Work Order ID 145378

Item Name: Replacement Skidtube (Fits LH or RH)

DRAWING NO. D2650	TITLE 206/407 SKIDTUBE ASSEMBLIES	REV. F	DART AEROSPACE LTD ENGINEERING ORDER		D.E.O. NO. D2650-F-1	SHEET NO. SHEET 1 OF 1	SCALE NTS
DRAWN <i>JP</i>	CHECKED <i>A.P.</i>	MFG. APPR. <i>DA</i>	APPROVED <i>HA</i>		DE APPR. <i>HA</i>		
DATE 12.10.12	DATE 12.10.22	DATE 12.10.22	DATE 12.10.22		DATE 12.10.22

CHANGE C'BORED WELDED CROSSBOLT SPACERS TO SWAGED SPACERS

DETAIL B

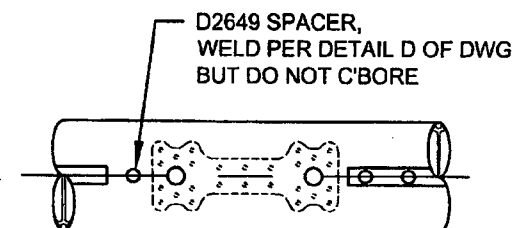
ADD DETAIL G BELOW, WHICH IS THE SAME SECTION VIEW AS DETAIL D OF DWG.

C'BORED HOLES ARE **NOW SWAGED** PER DETAIL G BELOW. FOR THE Ø0.375 HOLE THAT IS NOT C'BORED, WELD PER DETAIL D OF DWG (SEE AMENDED DETAIL B FOR REFERENCE).

AMENDMENT TO DETAIL B
NOT TO SCALE

DETAIL G

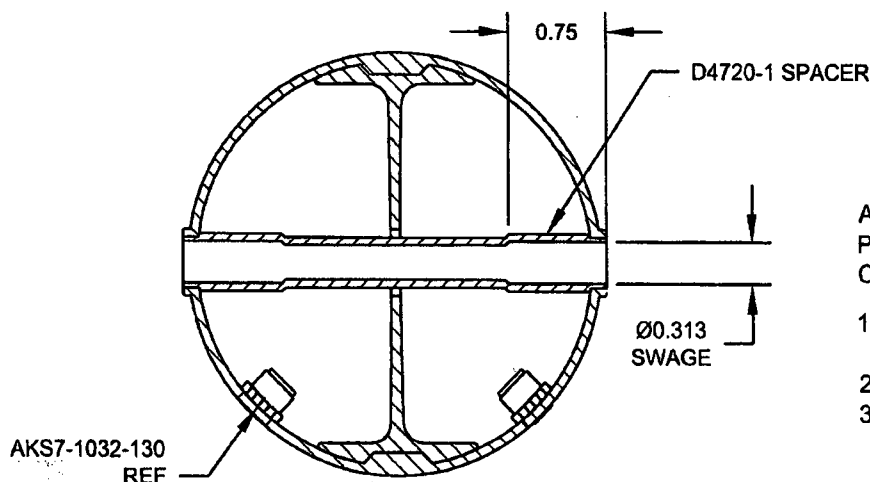
FOR Ø0.375 HOLES ONLY
FOR HOLES THAT ARE CURRENTLY C'BORED ONLY
NOT TO SCALE

AFTER DRILLING AND BENDING ASSEMBLY
PERFORM THE FOLLOWING FOR Ø0.375 HOLES THAT ARE
CURRENTLY C'BORED:

1. INSERT D4720-1 SPACER, 16 PL (-1) OR 17 PL (-3)
OR 19 PL (-5) OR 23 PL (-7)
2. SWAGE TO Ø0.313 X 0.75 DP PER QSI 002
3. TRIM / GRIND FLUSH PER QSI 002
